ADDENDUM 1

PROJECT NAME: APACHE CREEK LINEAR PARK LIGHTING UPGRADES

DATE: September 11, 2020

PROJECT NO: 29652000

SHEET:
ESD1.4A

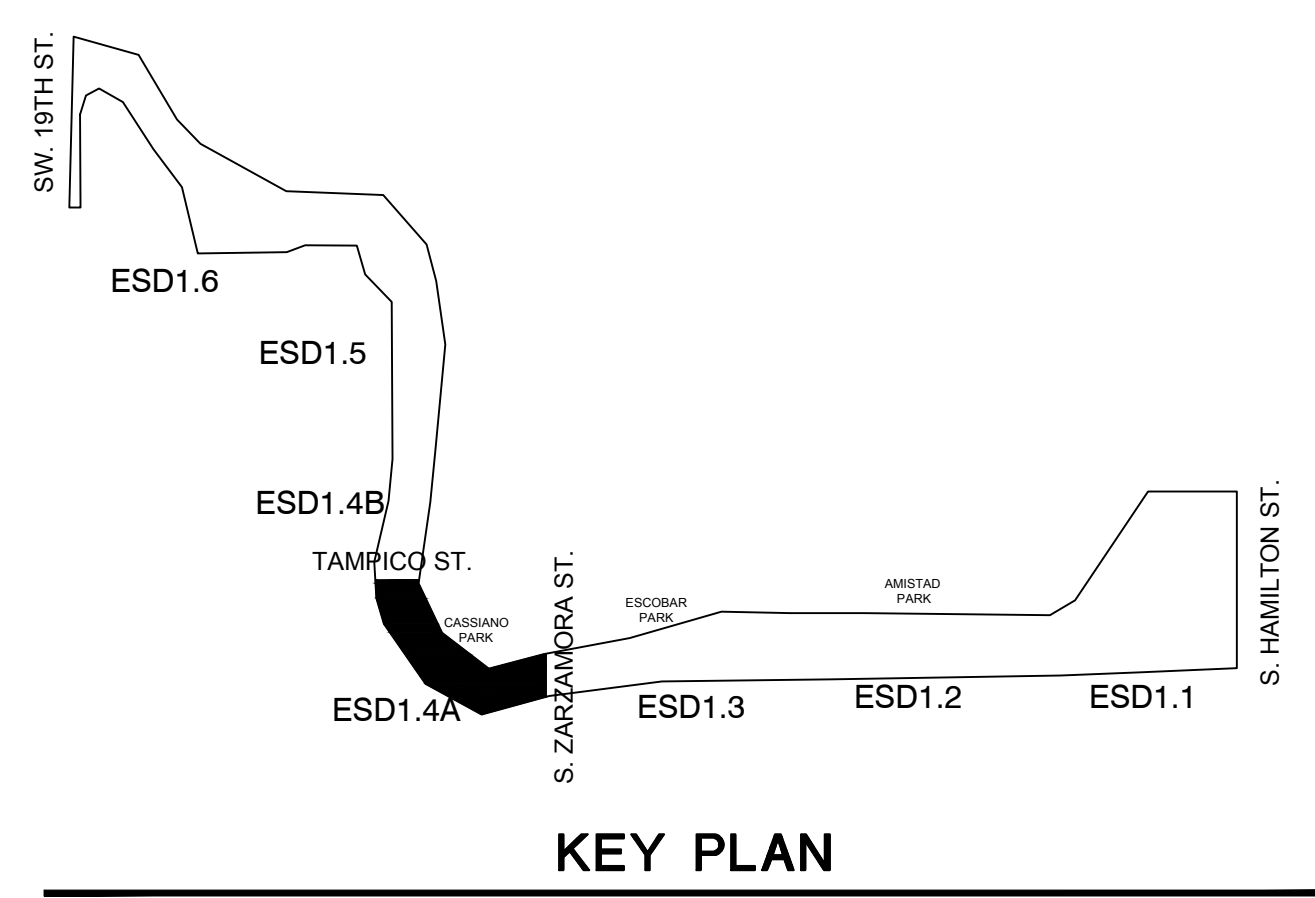
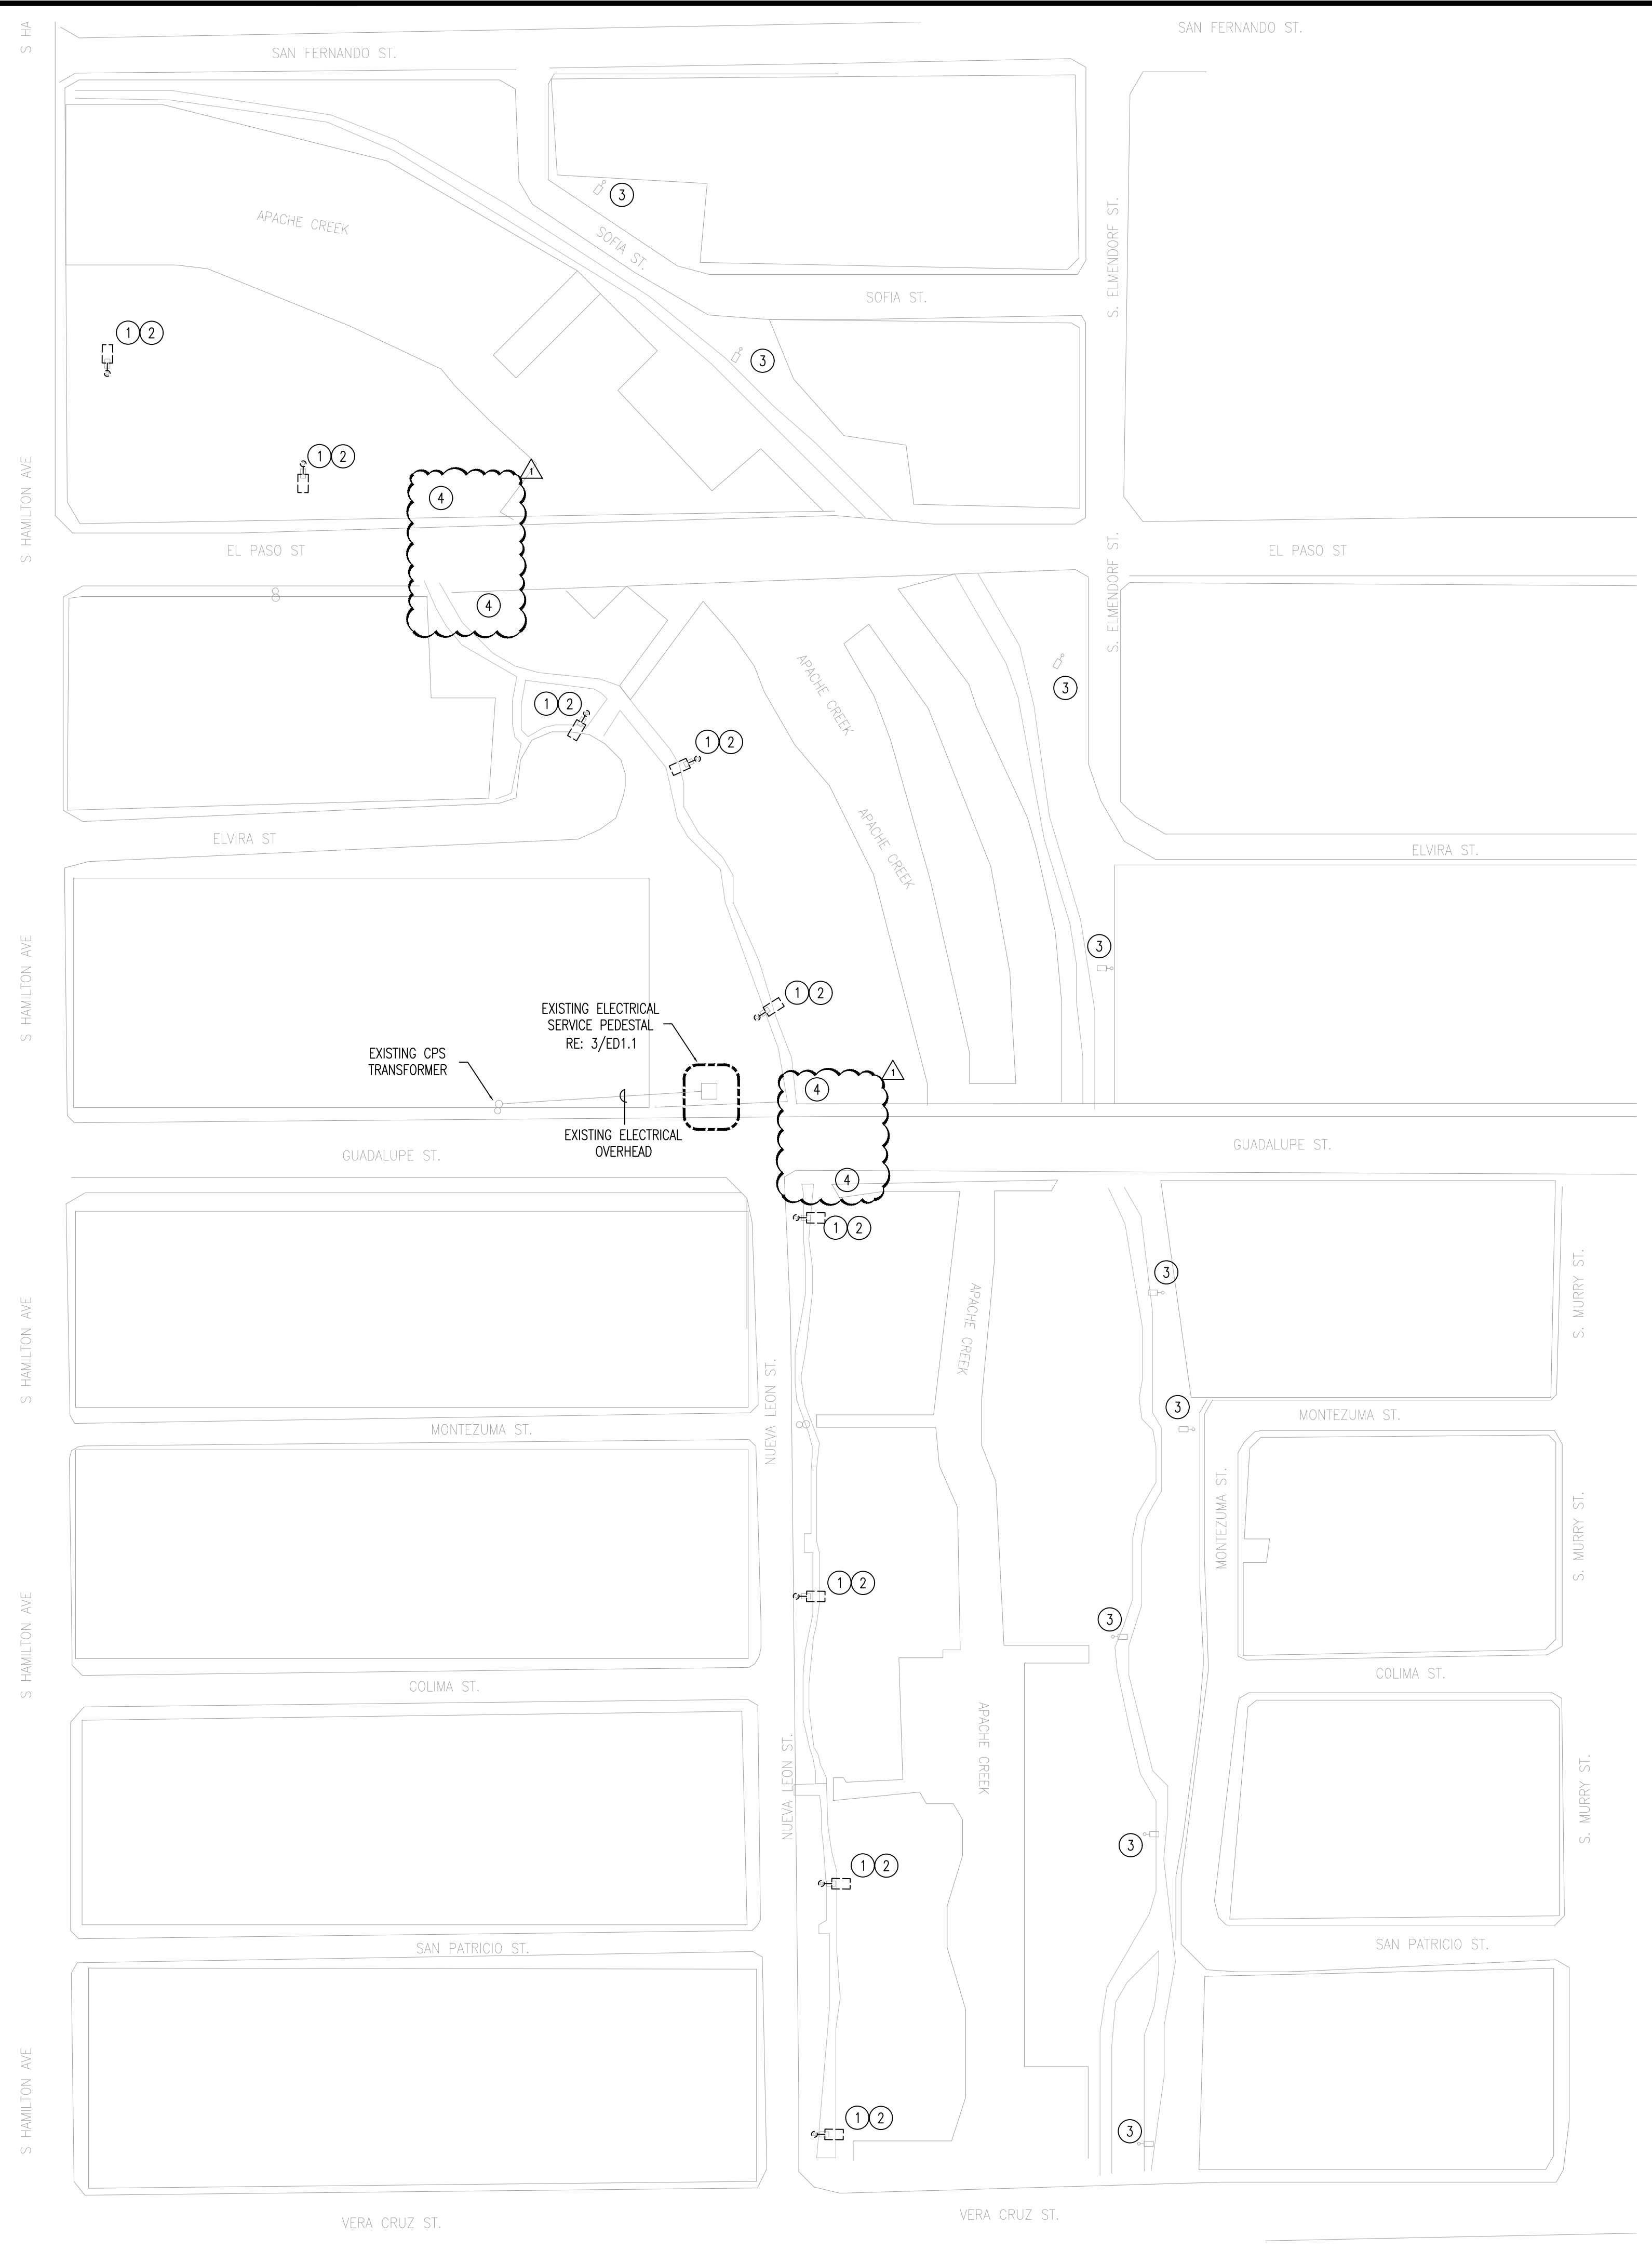
- b. Item 2: Added key note 3.
- iv. RE: Plan Sheet ESD1.4A:
 - a. Item 1: Revised key note 1.
- v. RE: Plan Sheet ESD1.4B:
 - a. Item 1: Revised key note 1.

- KEYED NOTES:** (APPLIES TO THIS SHEET)
- EXISTING LIGHT POLE AND ASSOCIATED ELECTRICAL COMPONENTS TO BE REMOVED. REMOVE ASSOCIATED POLE BASE DOWN TO 2'-0" BELOW GRADE, ABANDONED REMAINDER IN PLACE.
 - ALL UNDERGROUND CONDUIT SERVING LIGHT POLES TO BE ABANDONED 24" UNDERGROUND.
 - EXISTING LIGHT FIXTURE TO REMAIN.

SHEET:
ESD1.5

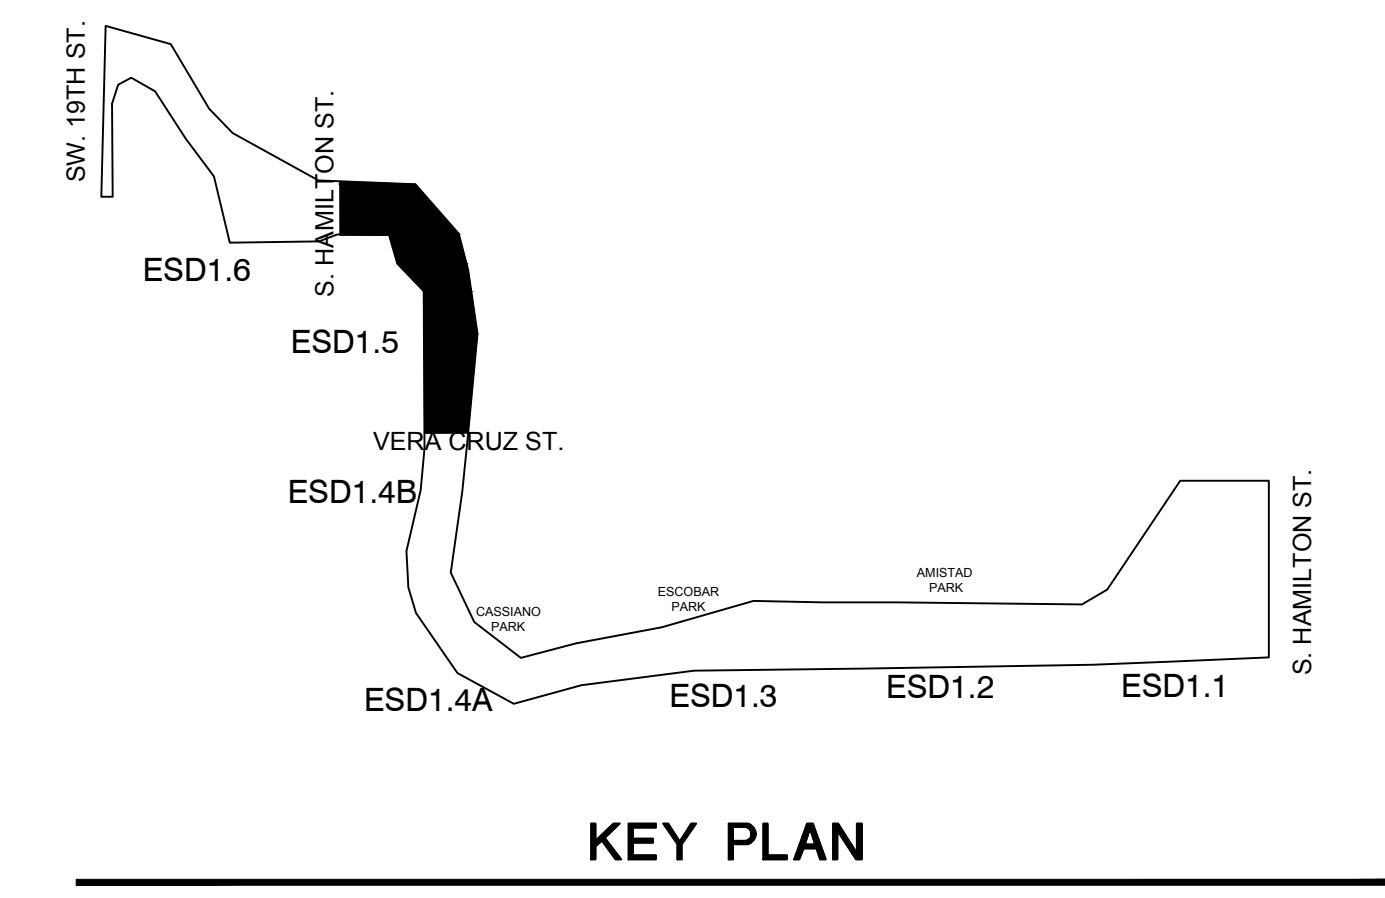
- vi. RE: Plan Sheet ESD1.5:
 - a. Item 1: Revised key note 1.
 - b. Item 2: Added key note 4.
- vii. RE: Plan Sheet ESD1.6:
 - a. Item 1: Revised key note 1 and 2.

- KEYED NOTES:** (APPLIES TO THIS SHEET)
1. EXISTING LIGHT POLE AND ASSOCIATED ELECTRICAL COMPONENTS TO BE REMOVED. REMOVE ASSOCIATED POLE BASE DOWN TO 2'-0" BELOW GRADE, ABANDONED REMAINDER IN PLACE.
 2. ALL UNDERGROUND CONDUIT SERVING LIGHT POLES TO BE ABANDONED 24" UNDERGROUND.
 3. EXISTING LIGHT FIXTURE TO REMAIN.
 4. EXISTING CONDUIT AND ASSOCIATED FEEDER ROUTED ACROSS BRIDGE TO BE REMOVE.

SHEET:
ESD1.6

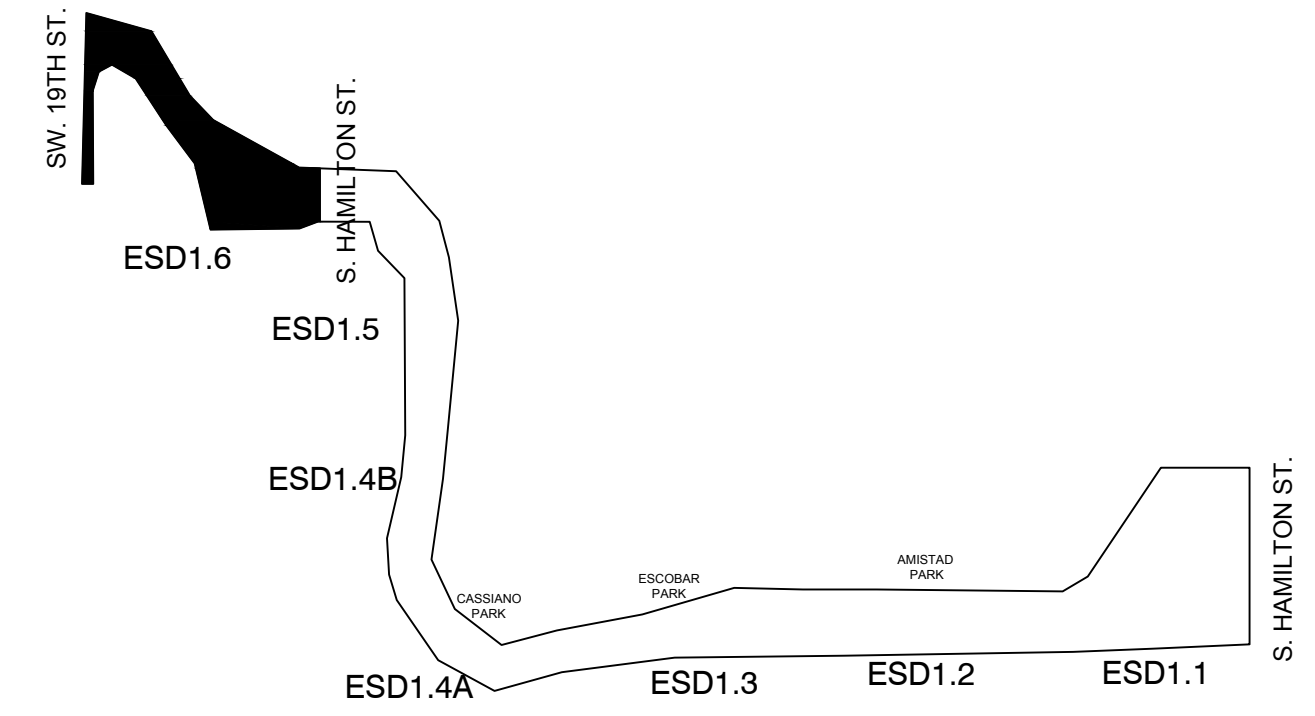
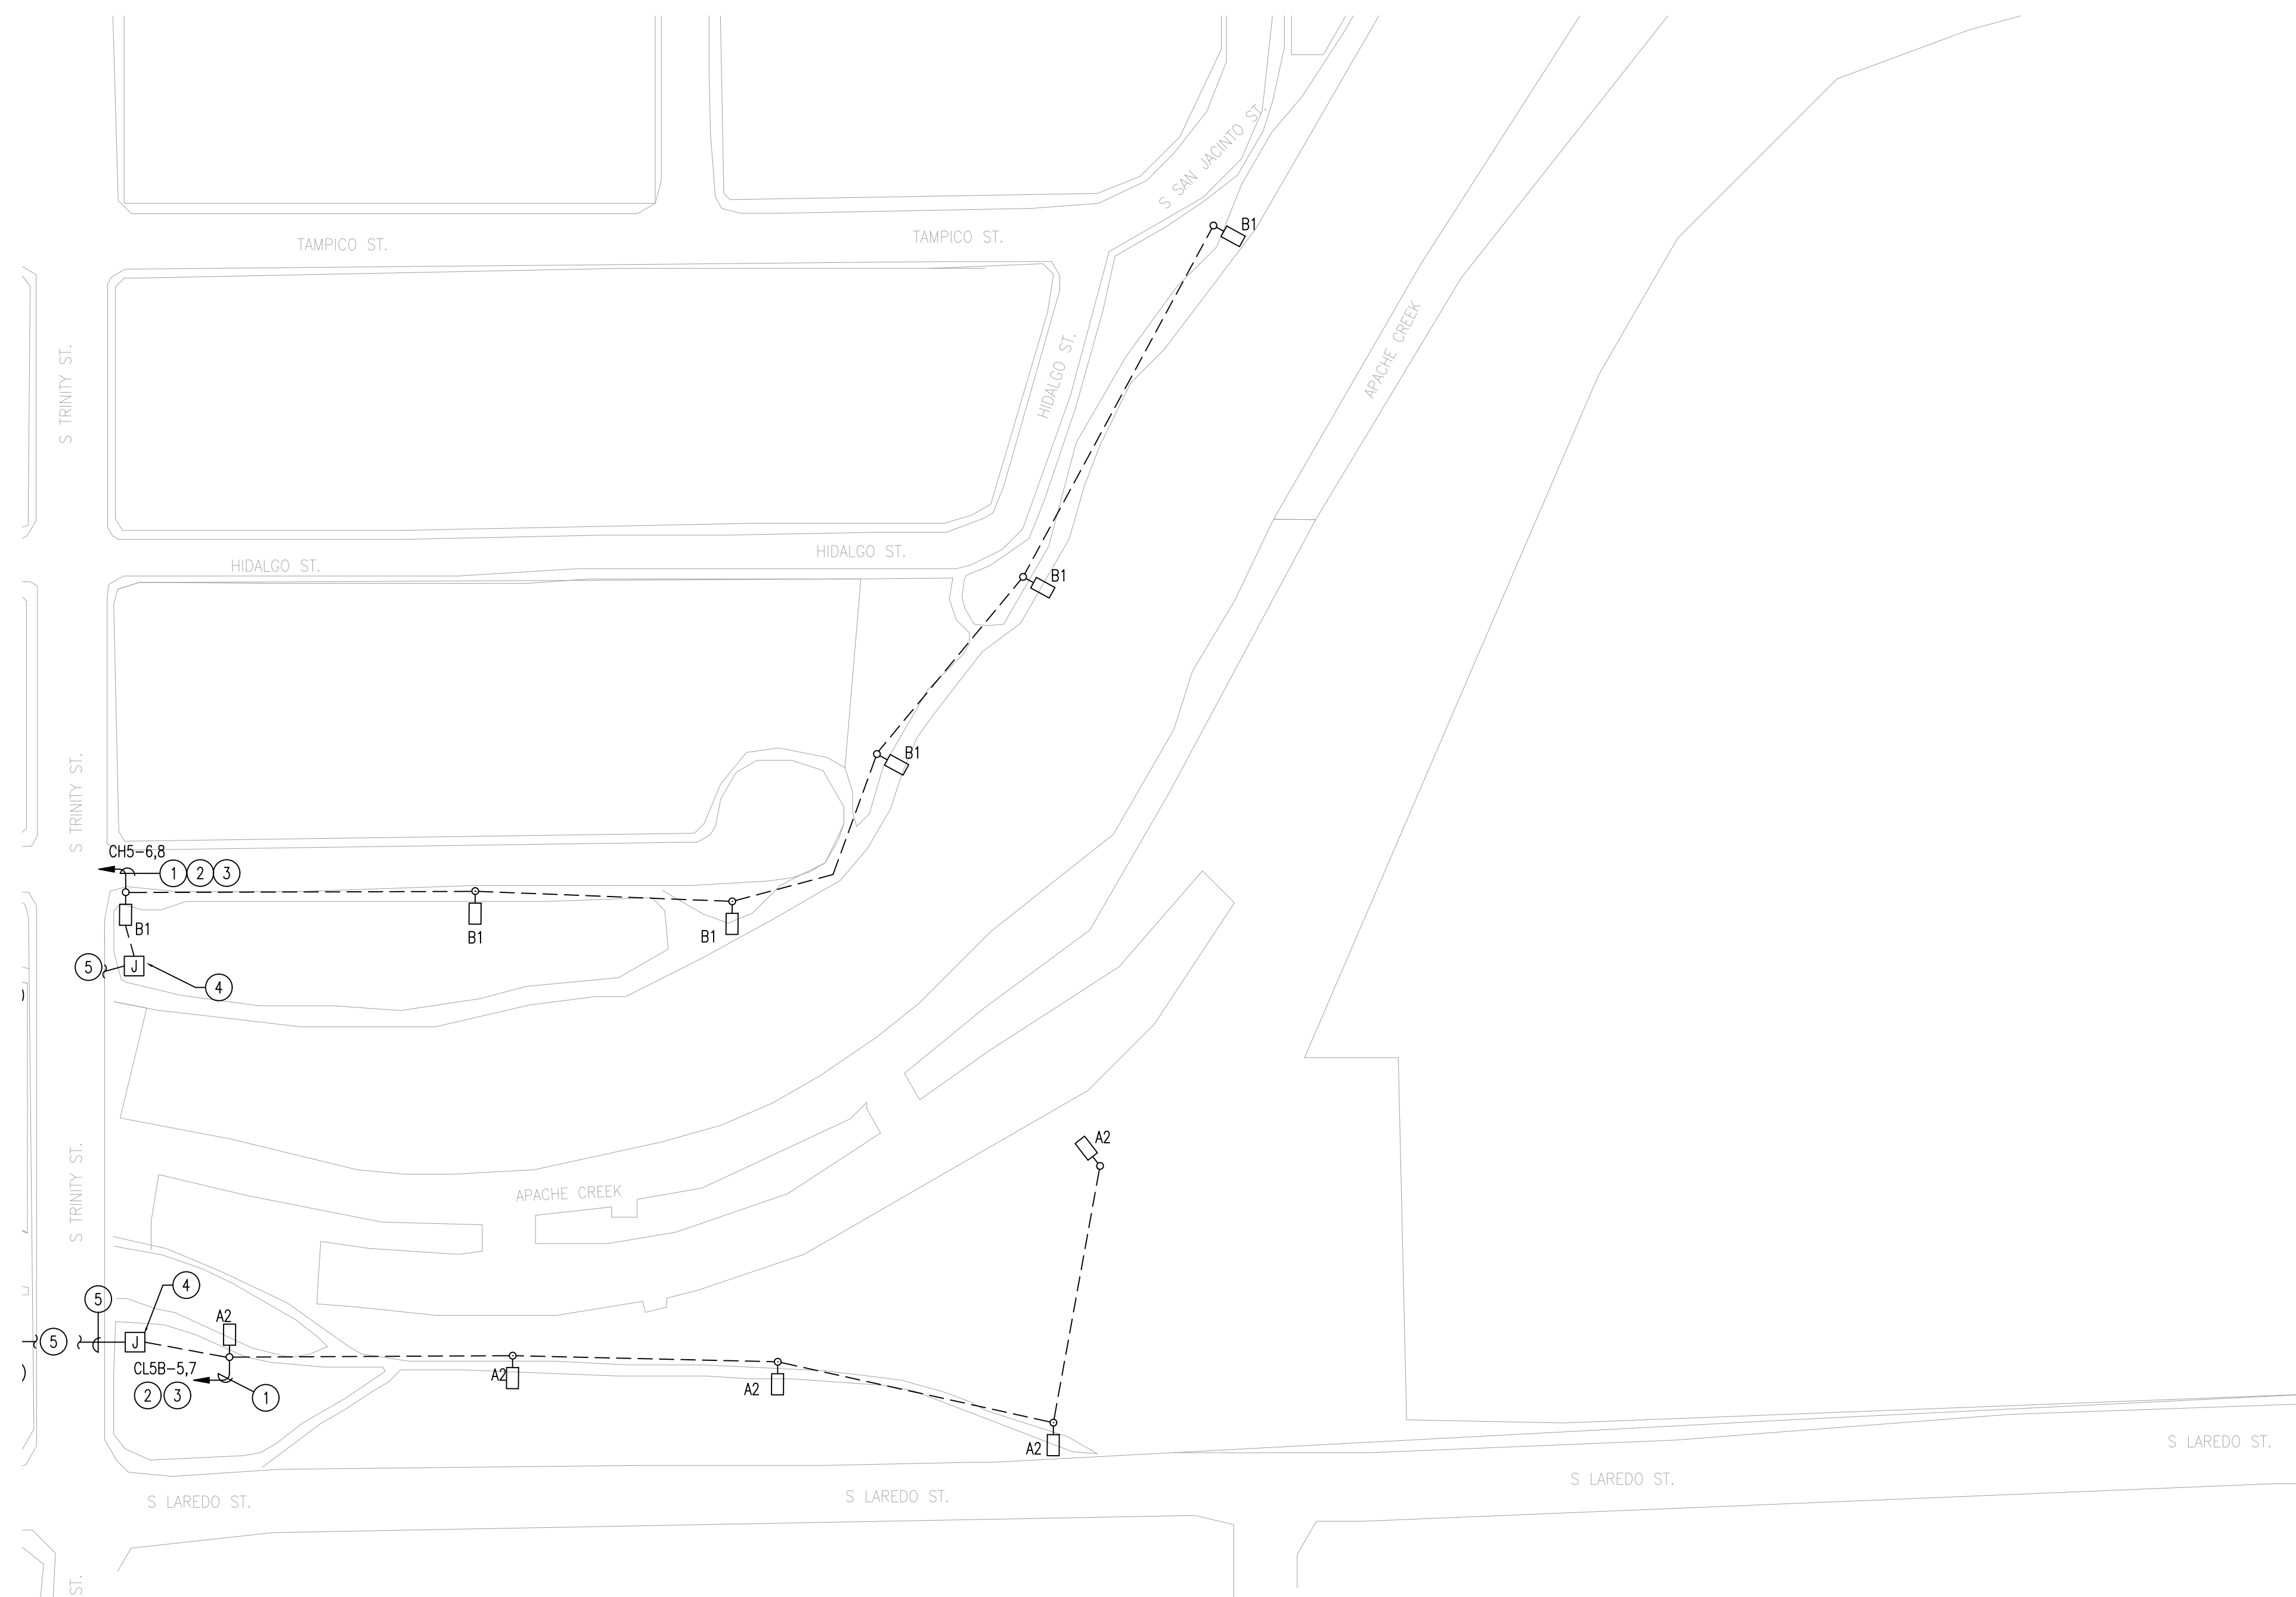
20. Will demo of existing conduit remain in place and removed in other areas?
- Answer: See revised key note 2 on demolition sheet ESD.6 for additional information. See addendum 01 drawings.

- EXISTING LIGHT POLE AND ASSOCIATED ELECTRICAL COMPONENTS TO BE REMOVED. REMOVE ASSOCIATED POLE BASE DOWN TO 2'-0" BELOW GRADE, ABANDONED REMAINDER IN PLACE.
- ALL UNDERGROUND CONDUIT SERVING LIGHT POLES TO BE ABANDONED 24" UNDERGROUND.
- EXISTING LIGHT FIXTURE TO REMAIN.
